Beacon Hill Civic Association Architecture Committee Comments for May 2022 BHAC Hearing

Reviewed by BHCA Architecture Committee at its monthly meeting on Tuesday, May 17, 2022.

30 CHESTNUT STREET:

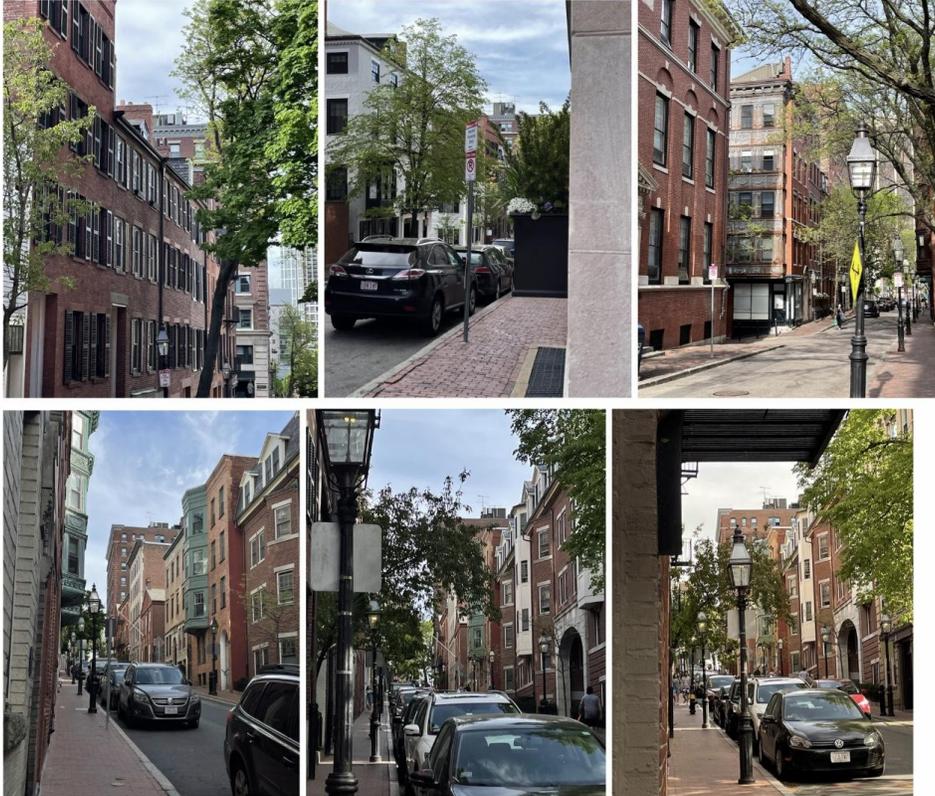
Comment: *We recommend denial of this application, and ask that the penthouse be reconstructed so as to not be visible from a public way. We do not suggest that the applicant rebuild what was there prior as that was non-historic and non-conforming and we ask that the Commission take the opportunity to correct the roofline of this townhome. We have submitted photographs of our determined extents of visibility that should be considered, and in relation to photographs we submitted in December 2019 of the prior conditions when a mock-up was supposedly in place but was not visible.*

Since the existing structure has been taken down and was non conforming to start with, there should be a new review for FAR and zoning relief as well as new plans submitted.
